63-65 Upper Chorlton Road, M16 7RQ

Approval Ref – 138589/FO/2023

Section 73 application regarding proposed window changes and amendment to Environmental Standards Statement

Conditions affected – 2 and 22

Above - plan showing locations of affected windows

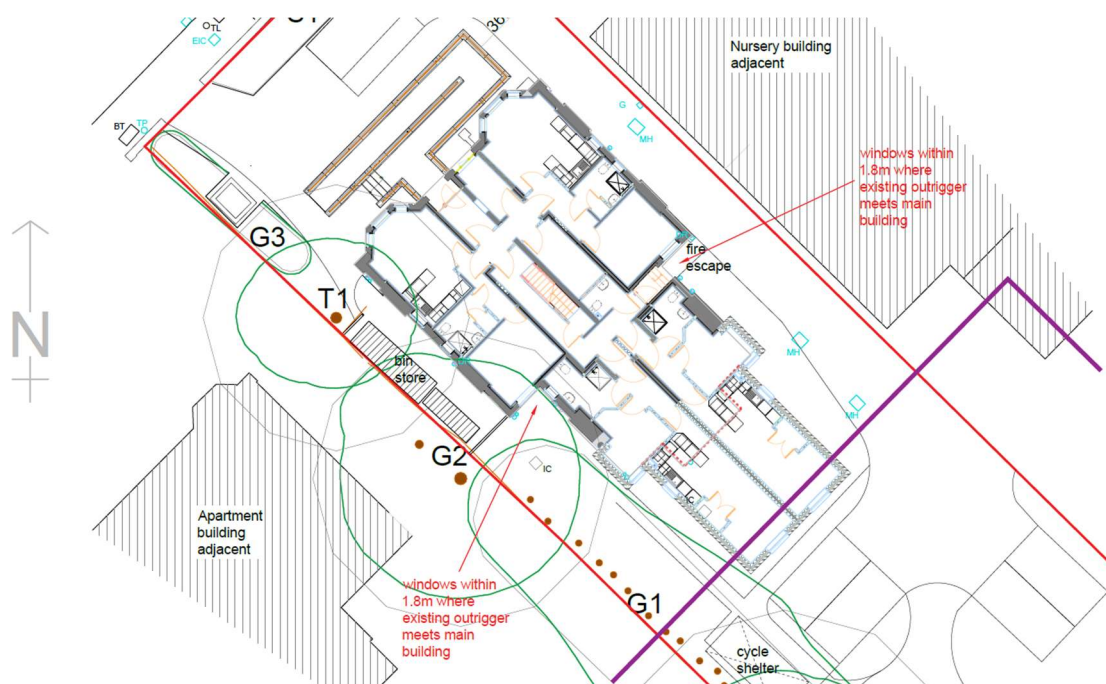
As part of the design development process, the Fire Risk Assessment for the proposed scheme has identified areas where fire rated windows would be required to meet Building Regulations requirements.

This occurs where windows are within 1.8m of one another on flanking elevations, specifically, where the original rear outrigger meets the main house. That is, the main bedroom windows in the rear elevation are within 1.8m of the bathroom and smoke ventilation windows in the side elevations.

Side Elevation (North)

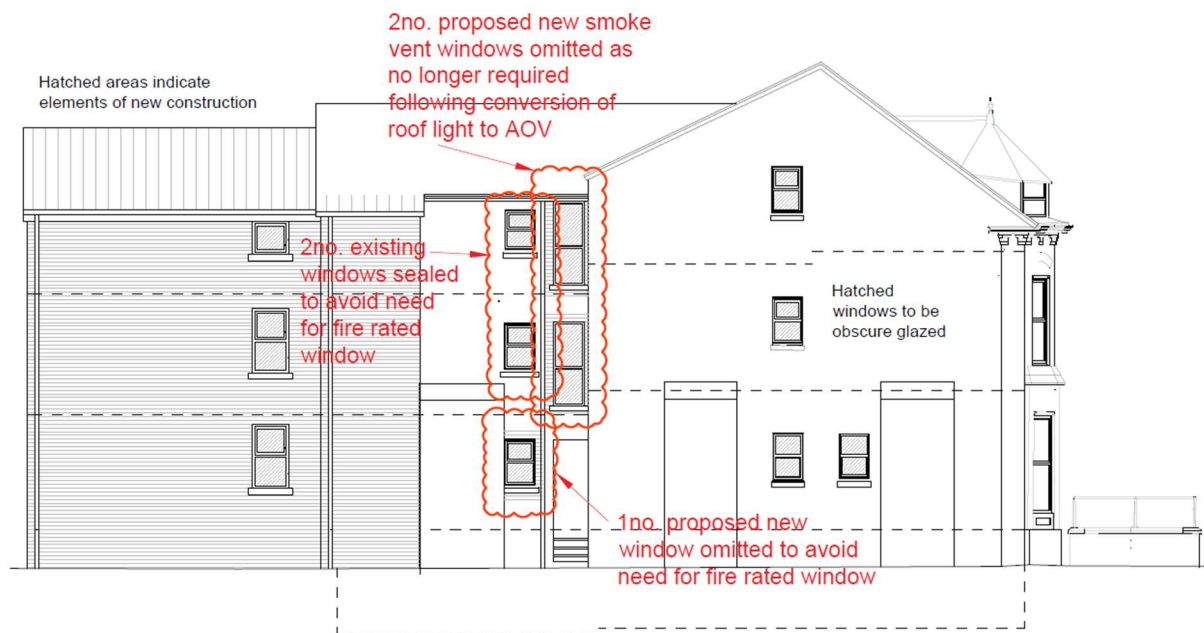
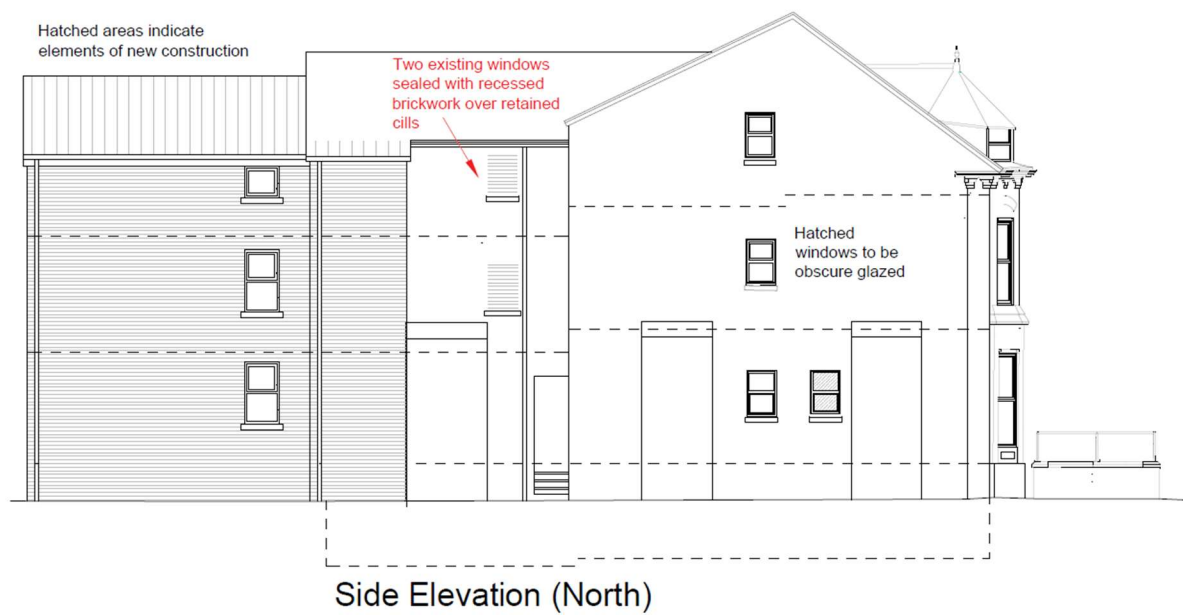
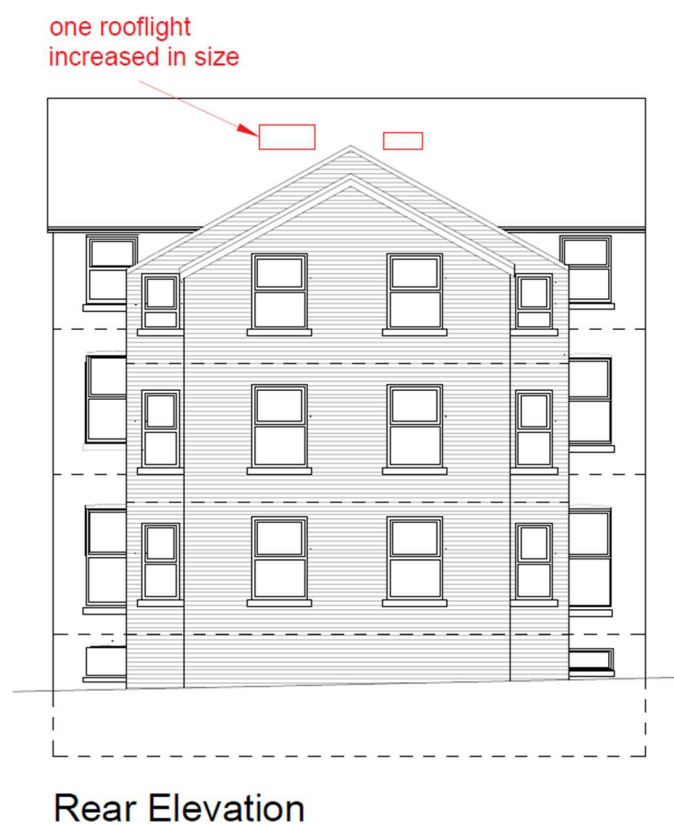
It is possible to incorporate fire rated windows into the bathrooms on the south facing outrigger elevation, without significant impacts on the usability of the flats. However on the north side, the presence of windows which act as smoke vents to the stair, mean that the bedroom windows would need to be fire rated. This would have implications for room ventilation and external appearance.

To avoid these issues it is proposed to replace the smoke vents in the north facing outrigger wall with an automatic opening vent at roof level. This would be achieved by increasing the size of an existing rooflight over the stair.

As we are aware that there were concerns at planning stage about the presence of windows in this elevation (due to the risk of overlooking the adjacent nursery), we are also proposing to omit the three small bathroom windows on the north elevation. One of these is a new window, which would simply be omitted. The other two are existing windows which would be sealed with new brickwork set back from the main elevation.

Above – roof plan showing proposed solar panel layout

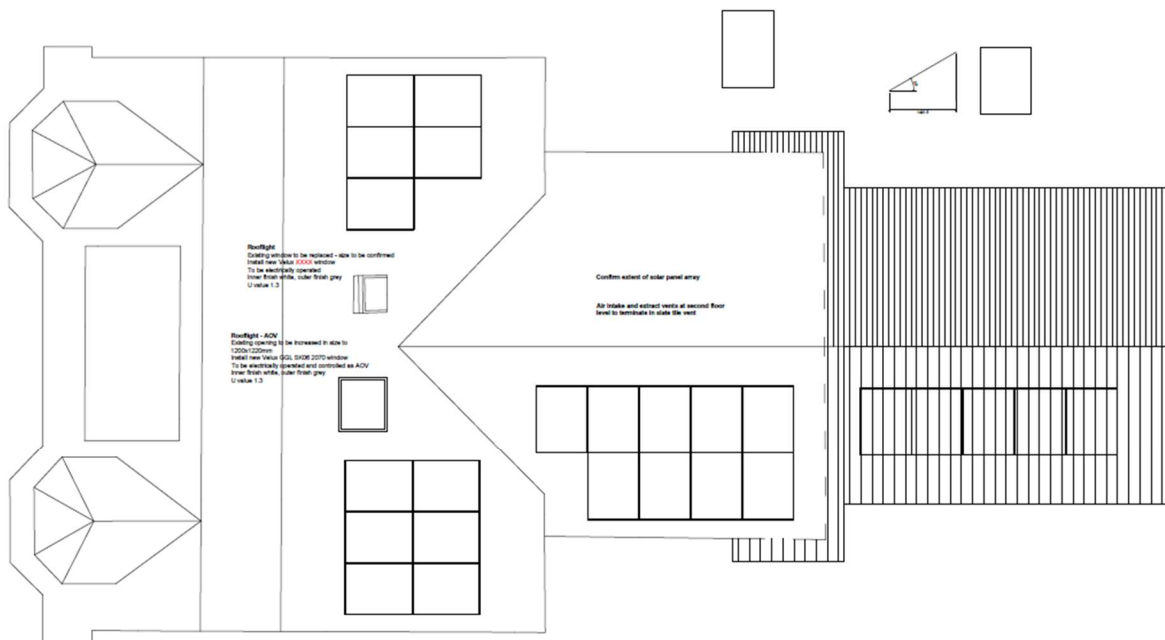
As part of the design development process more detailed calculations have been carried out which have resulted in changes to the preferred approach. Therefore a ne Environmental Standards Statement is being submitted as part of this application (Watt Energy, 16 October 2024). This still adopts solar PV and air source heat pumps as the preferred energy solution, however the number of panels has now been reduced from 37 to 25. The proposed layout of these panels is shown below.
